Eastern Area Planning Committee

Wednesday, 7th February, 2018 at 6.00 pm

UPDATE REPORT

Item No: (1) **Application No:** 17/03079/COMIND **Page No.** 25 - 41

9 Brownlow Road, Cambridge, CB4 3NG
 Tel: 07825 868654

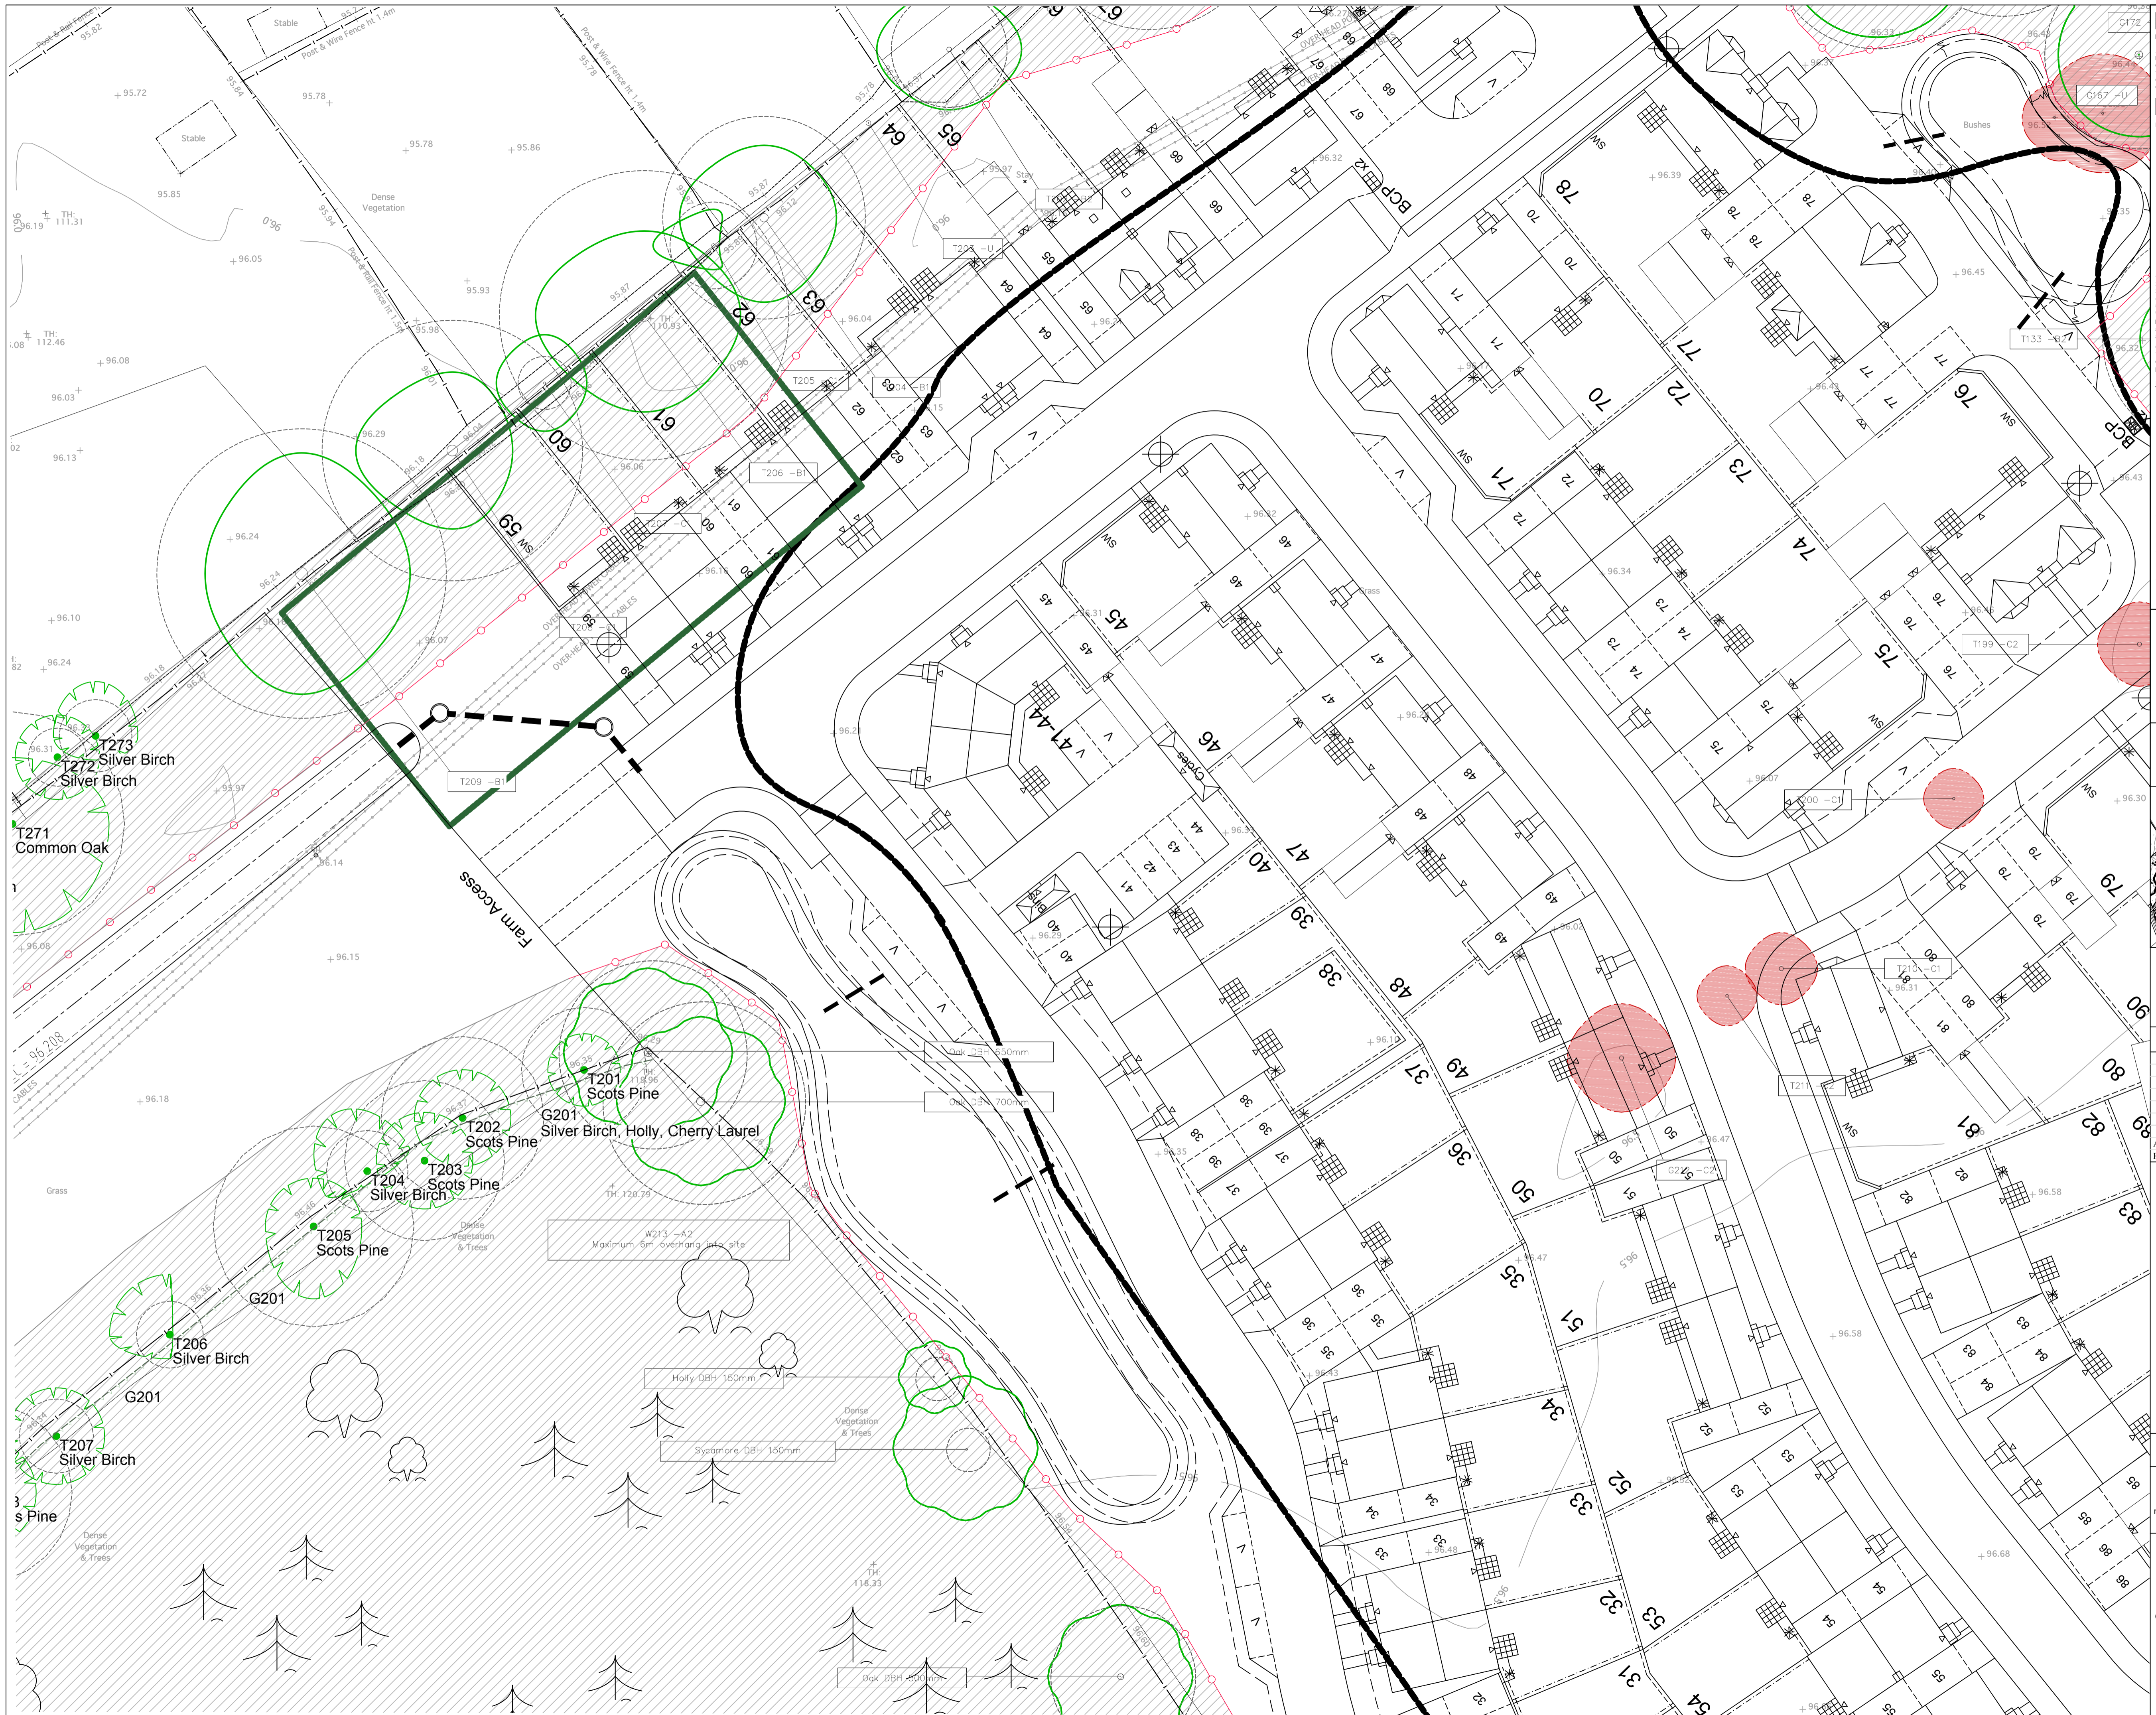
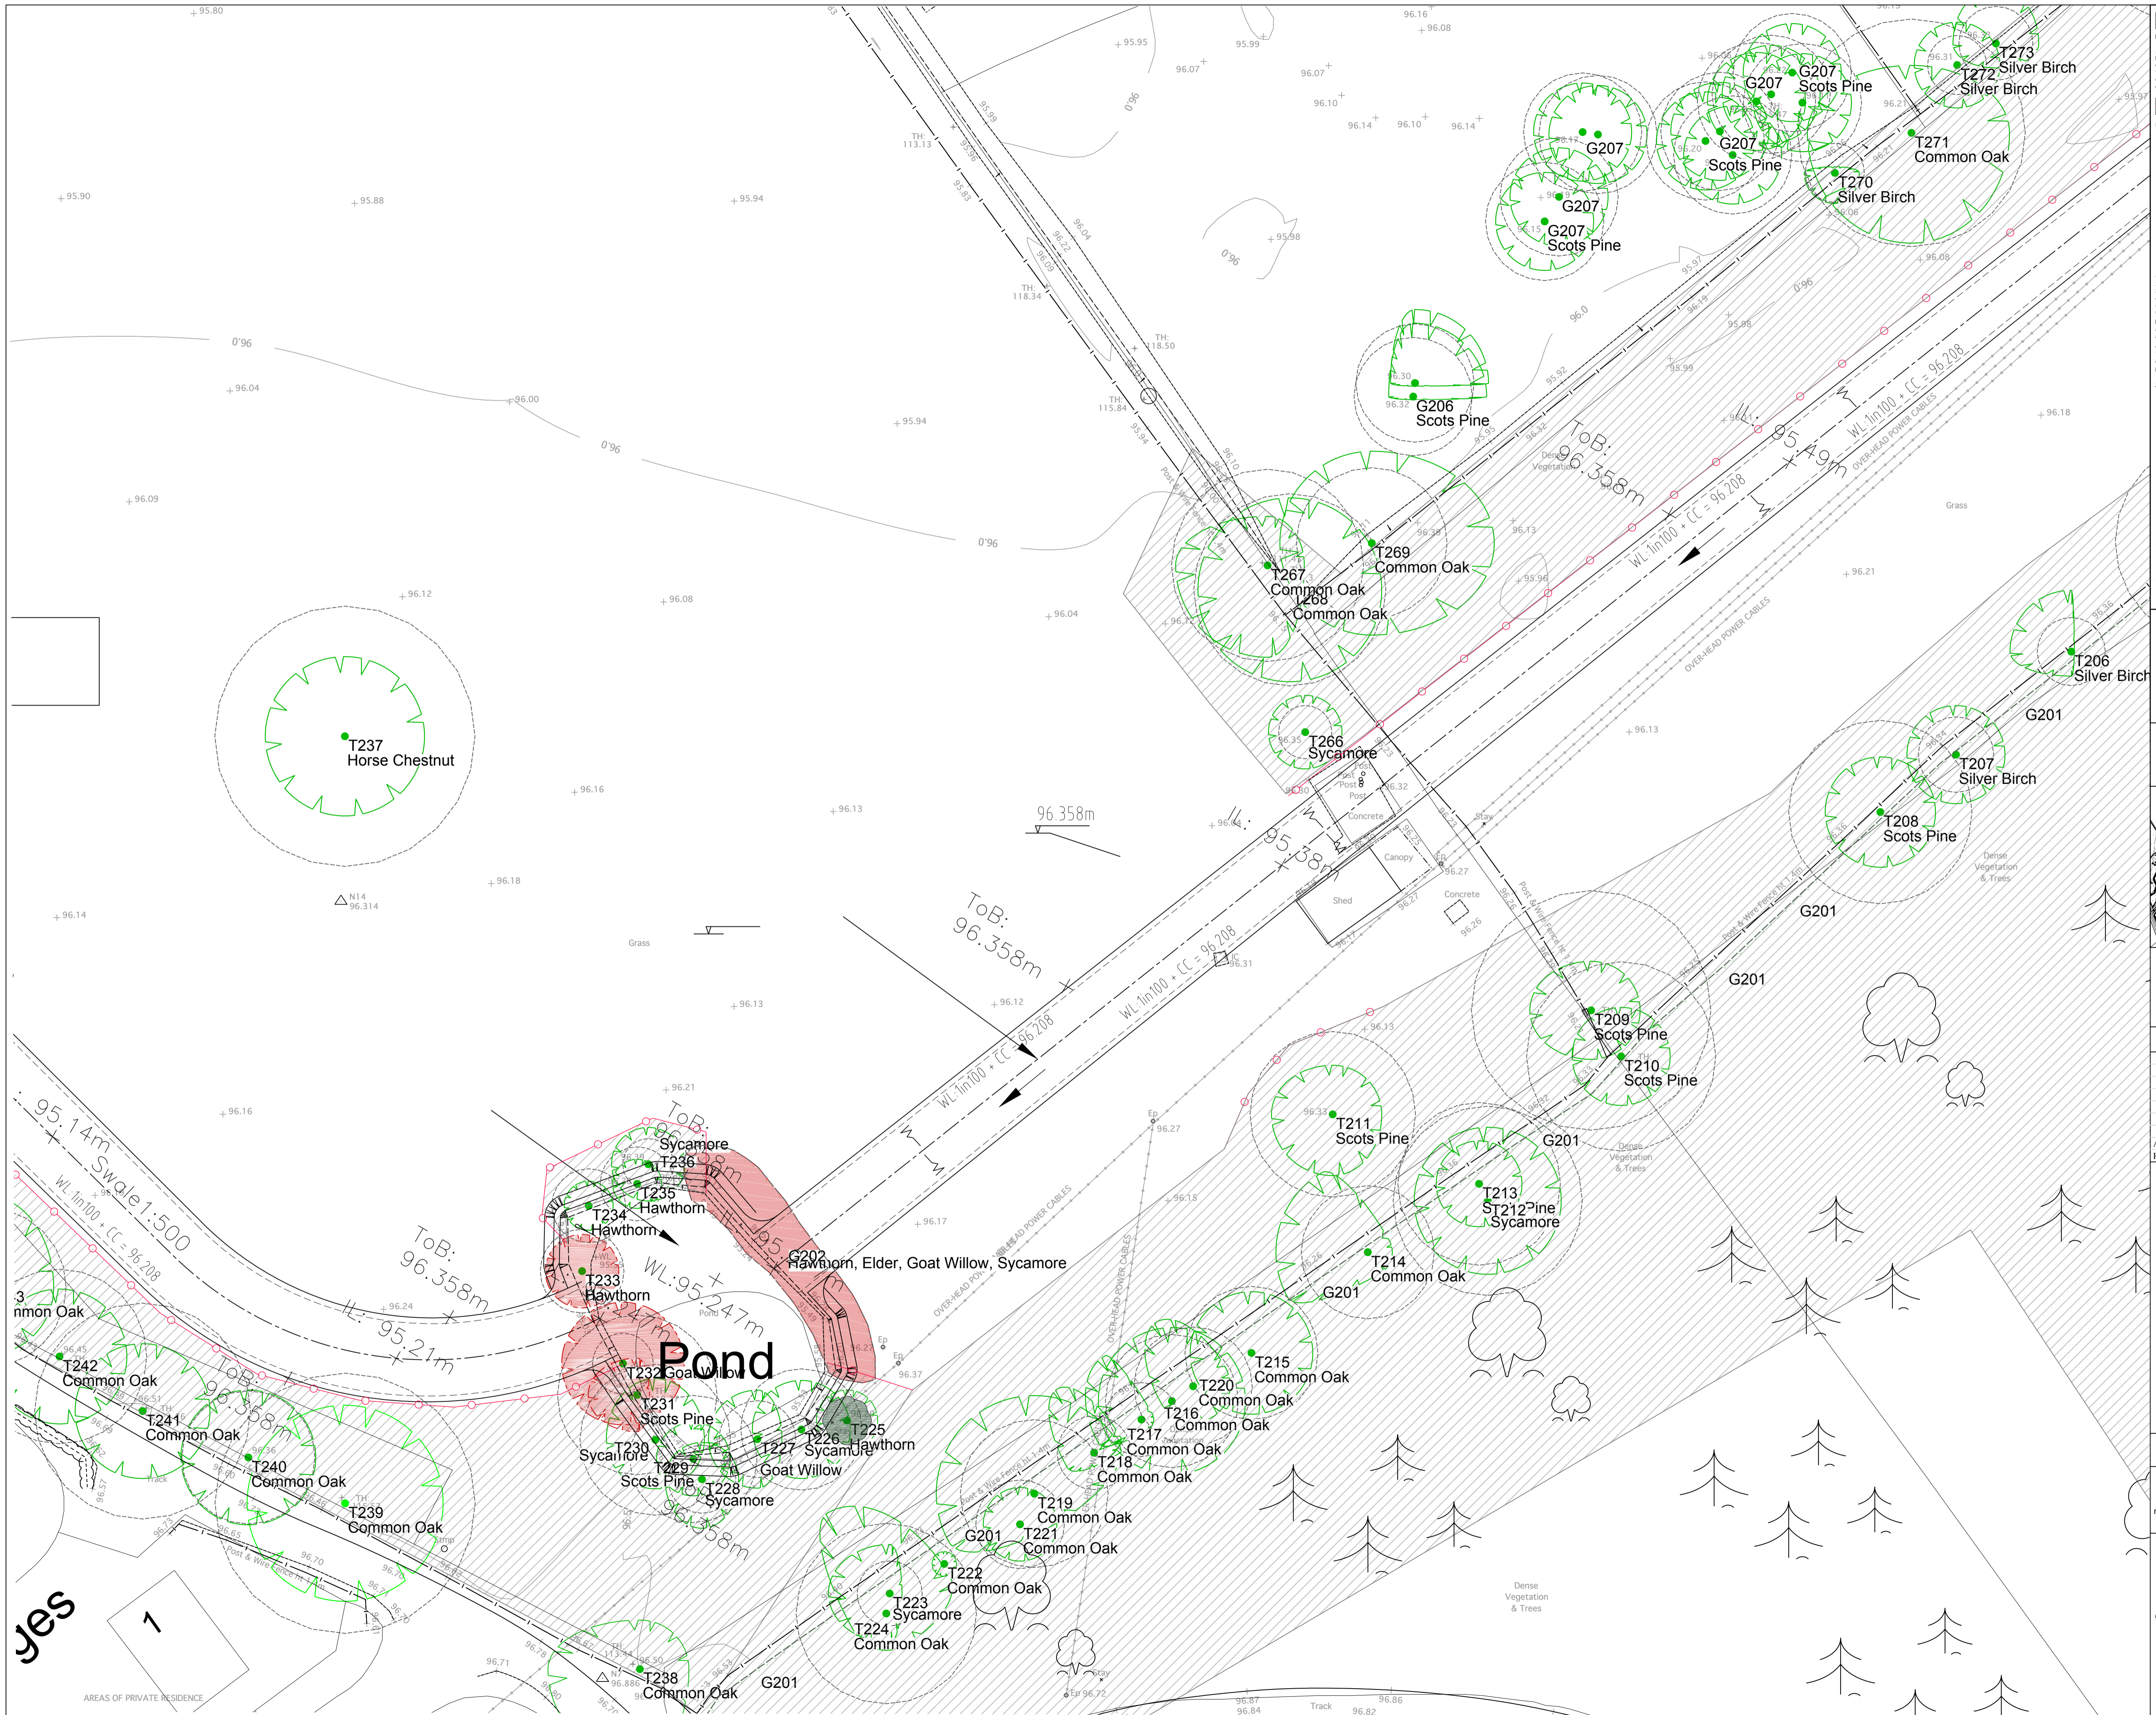
The approved drawings are attached showing the trees to be removed in red.
